# CITY OF ALBUQUERQUE

**RE:   Maverik Juan Tabo & Cooper  
      650 Juan Tabo Blvd NE  
      Grading and Drainage Plan & Drainage Report  
      Engineer's Stamp Date: 01/30/19  
      Hydrology File: K22D059**

DRAWN BY  
pm  
DATE  
1-29-19  
DRAWING  
2018046-DR  
SHEET #  
**C3**  
JOB #  
2018046

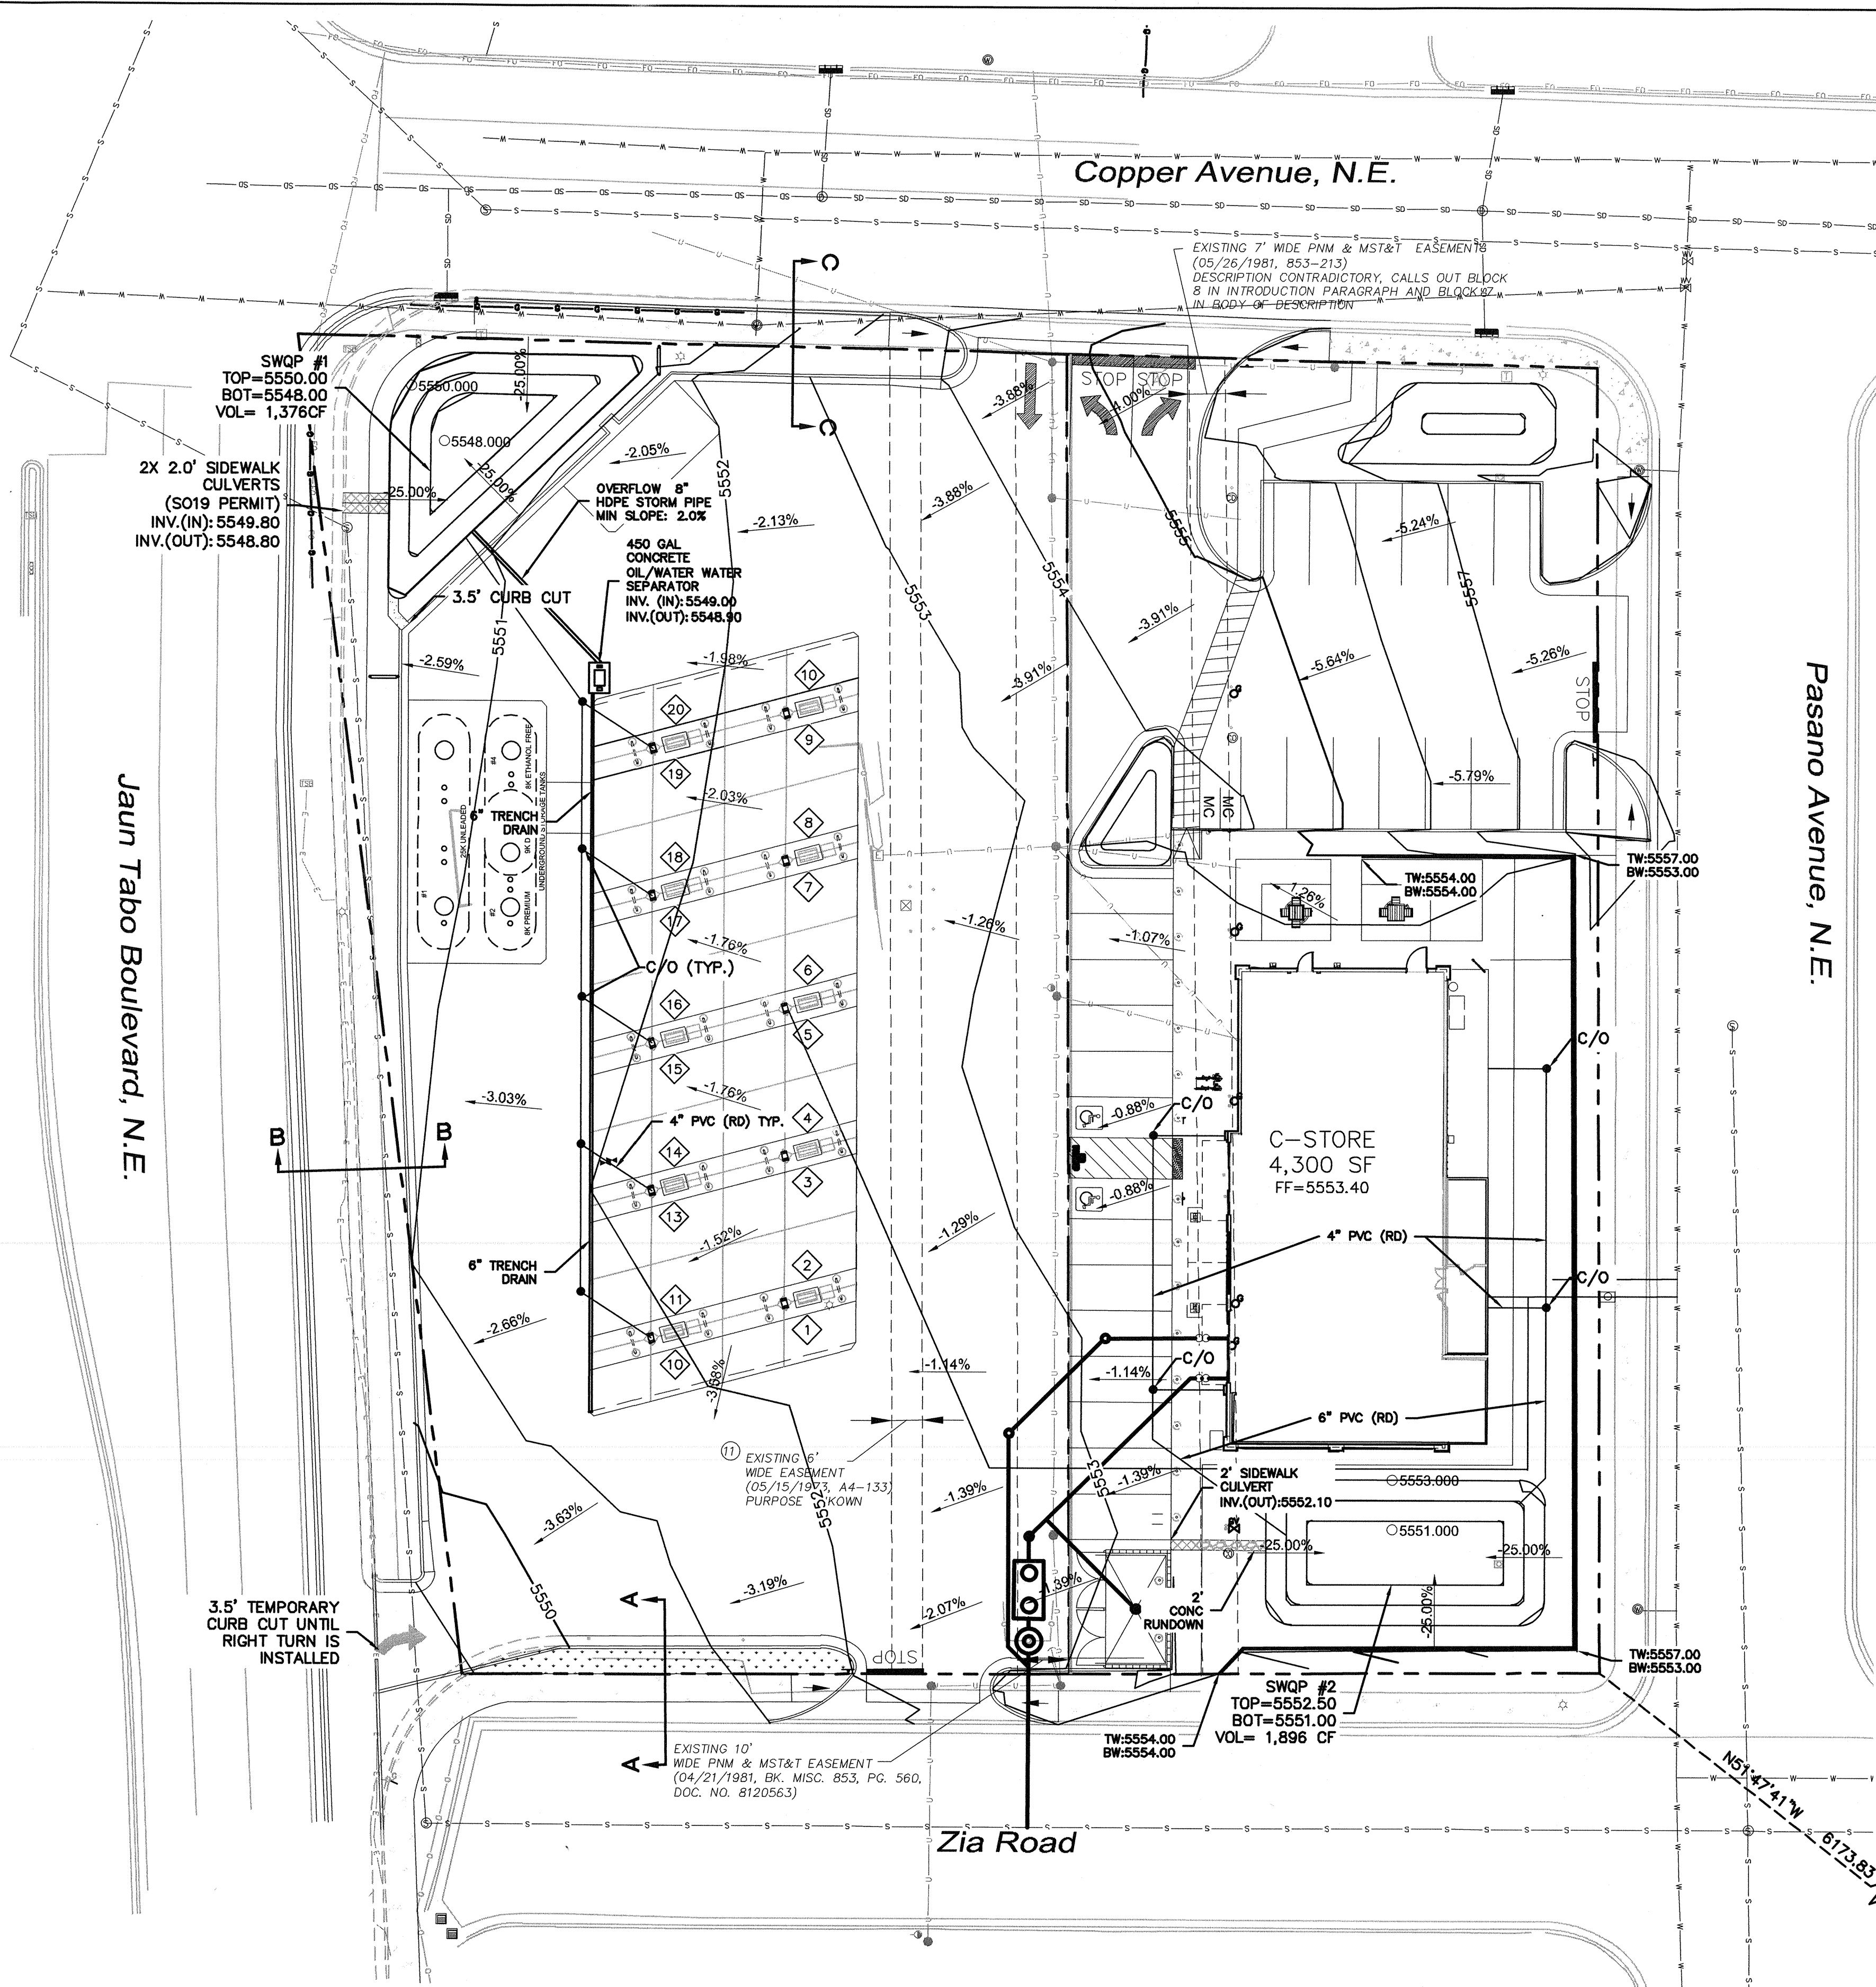
9. Sheet C3 and Drainage Report. Please add an existing watershed exhibit with discharge points. This can be the existing aerial photo with flow lines and existing 2 ft contours.
10. Sheet C3 and Drainage Report. Please add the existing condition runoff calculations.
11. Sheet C3 and Drainage Report. SWQP #2 does not need to be this big unless it is needed. All it needs to handle is 153 (B1) + 294 (B2) for a total of 447 CF. Watershed B2 can be allowed to free discharge if you handle the volume in SWQP #2 and payment-in-lieu will not be needed for watershed B2.
12. Standard review fee of \$150 will be required at the time of resubmittal. When resubmitting, please just ask for Site Plan for Building Permit approval. Once the site plan is approved by the DRB, then ask for Building Permit, Grading Permit, and SO-19 Permit approval.

ENGINEER'S SEAL	MAVERIK 650 JUAN TABO BLVD. NE GRADING PLAN	DRAWN BY pm
			DATE 1-29-19
		TERRA WEST, LLC 5571 MIDWAY PARK PL NE ALBUQUERQUE, NEW MEXICO 87109 (505) 858-3100 www.tierrawestllc.com	DRAWING 2018046-GR
			SHEET # C2
			JOB # 2018046

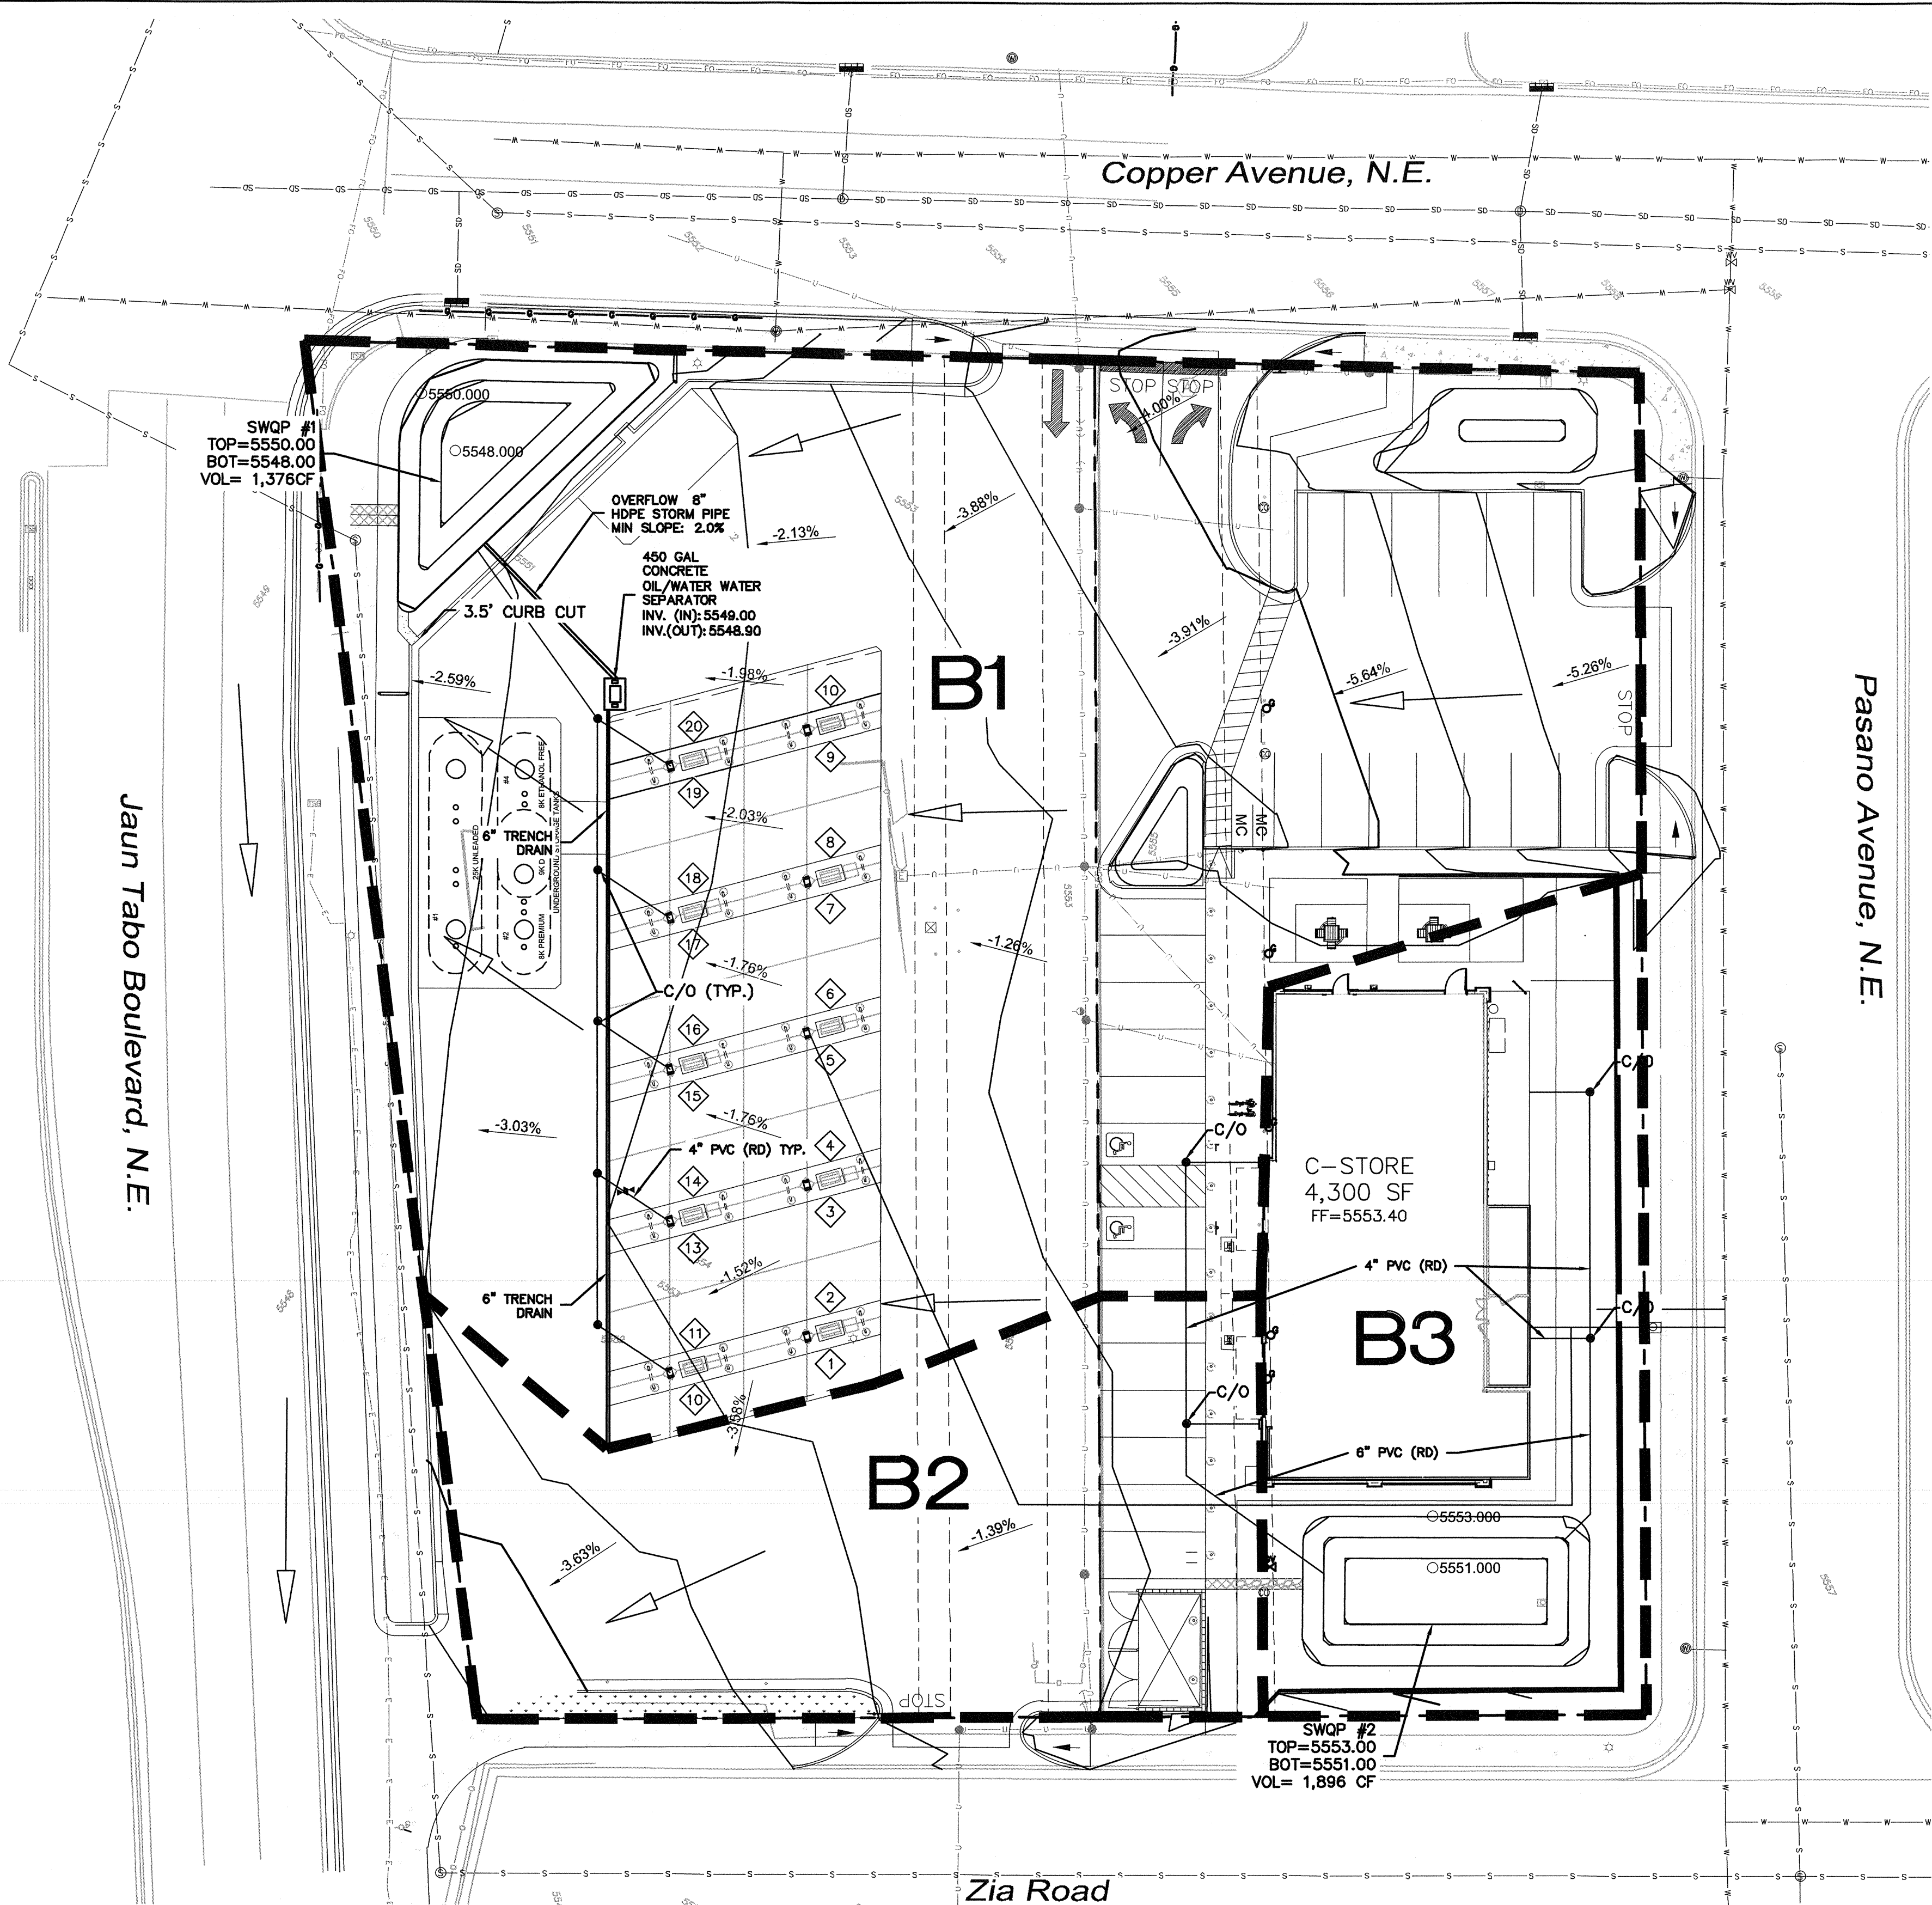
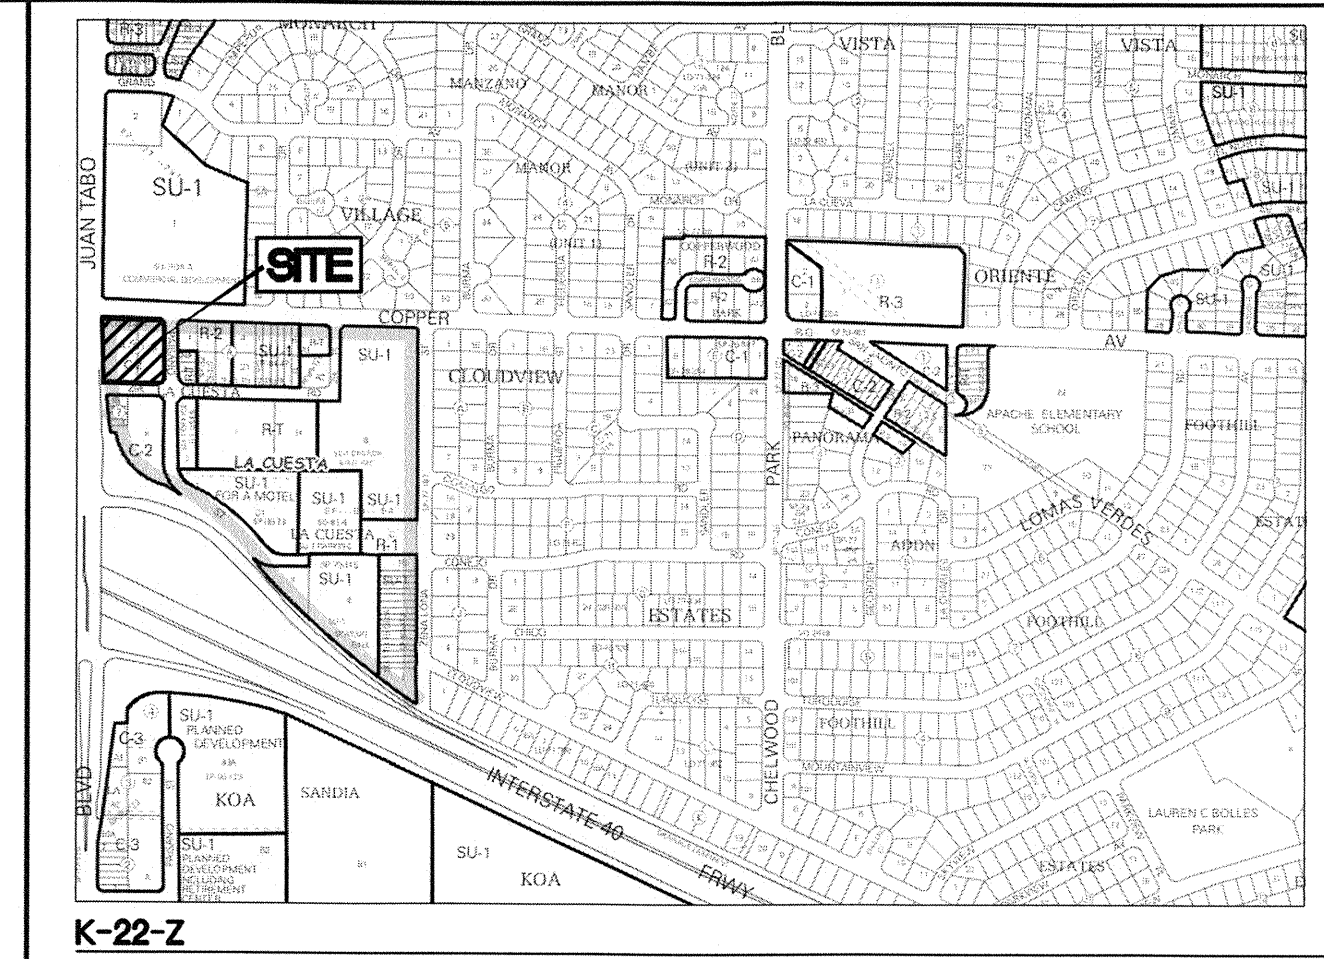
1. Please add the word "Conceptual" to the sheets title and add a note stating "Not for Construction".
2. Please correct the spelling of Juan Tabo Blvd on both sheets.
3. Sheet C2. Please add a cross section of both storm water quality ponds along with the water surface elevation of the SWQ volume.
4. Sheet C2. Please add the invert (in) elevation of the sidewalk culvert in SWQP #2.
5. Sheet C2. Please clarify and label the future curbing along Juan Tabo, "Future curbing pending NMDOT approval."
6. Sheet C2. Please add a note to the proposed sidewalk culverts, "May be extended to the existing curb if NMDOT does not approve the right turn entrance."
7. Sheet C2. Please show the temporary curb cut extended to the existing curb and not stopping at the future curb.
8. Sheet C2. Please add a note that the right turn is pending NMDOT approval.
